Kids' Bedrooms

Other Vaulted Ceiling Areas

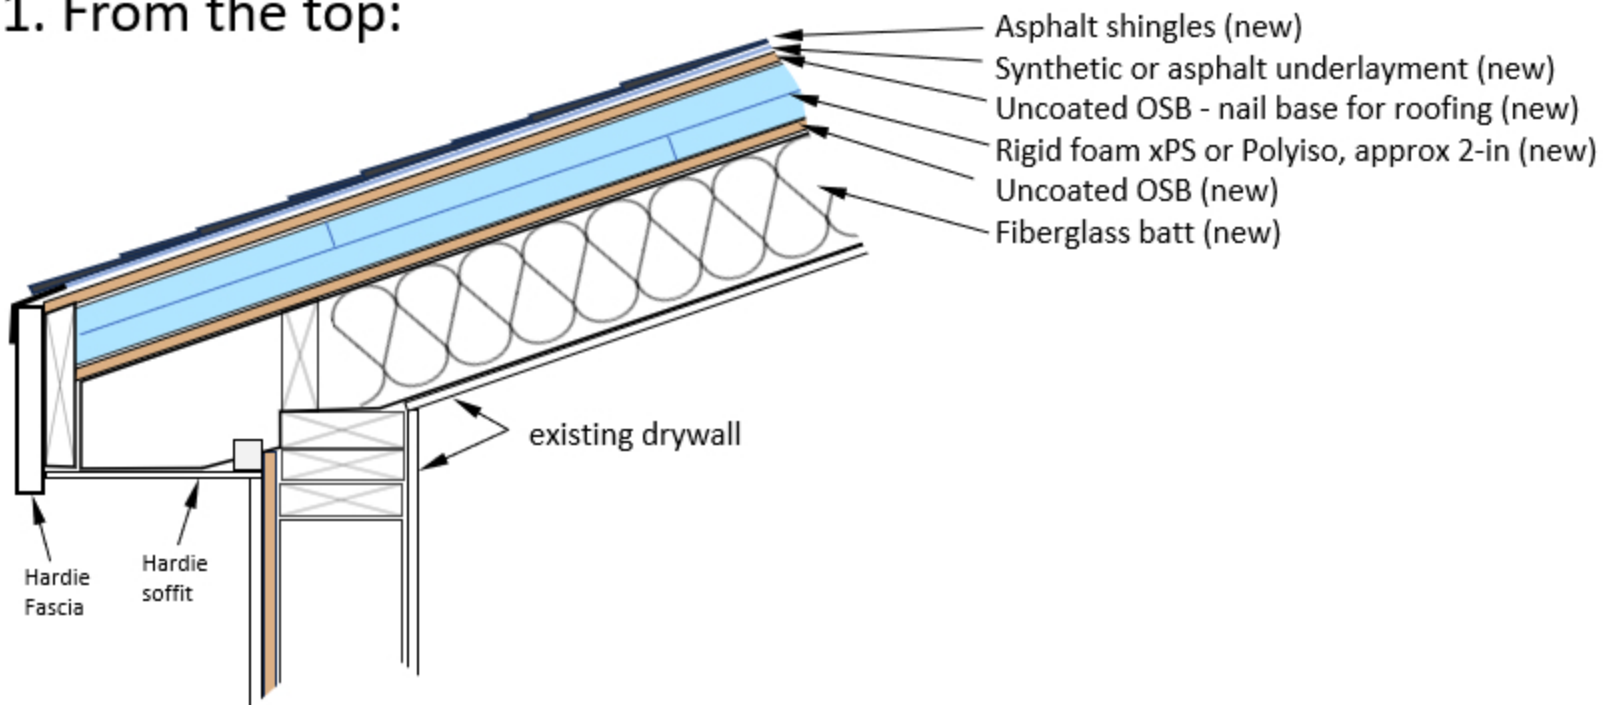
PROBLEMS:

- Aluminum facers on the polyiso foam
- Radiant barrier on OSB limits drying to the interior

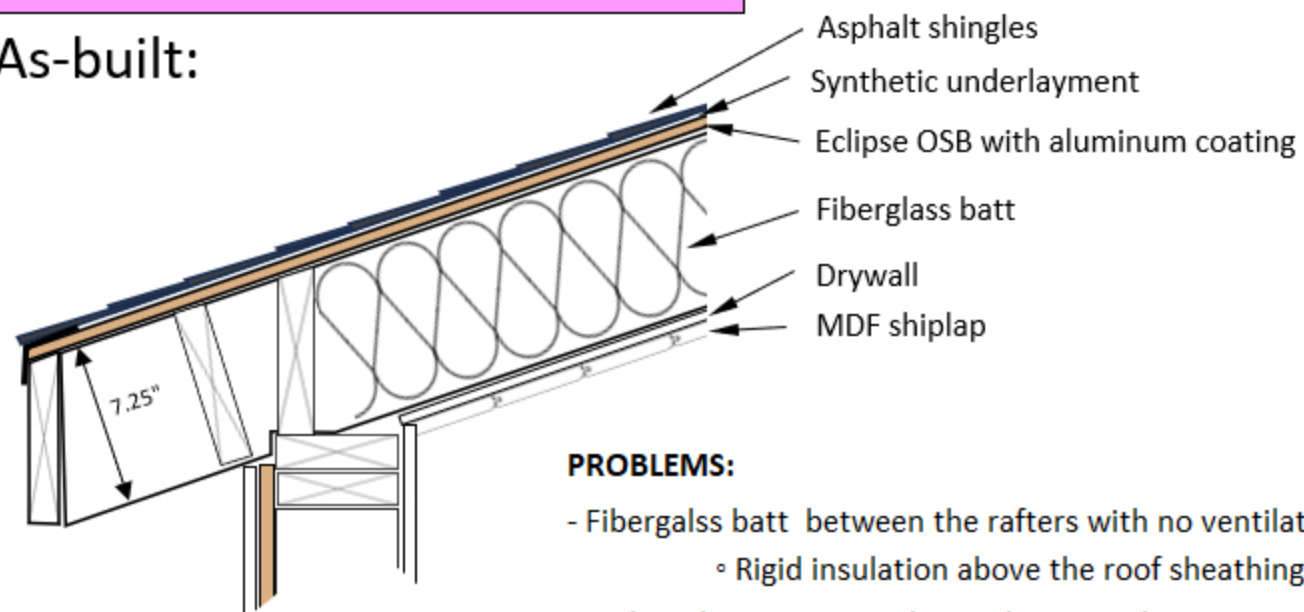
PROBLEMS:

- Fiberglass batt between the rafters with no ventilation also requires:
 - Rigid insulation above the roof sheathing: CRC R806.5 - 5.1.2.
- Radiant barrier on OSB limits drying to the interior
- R-value is approximately 25 for this area (R-30 requirement)
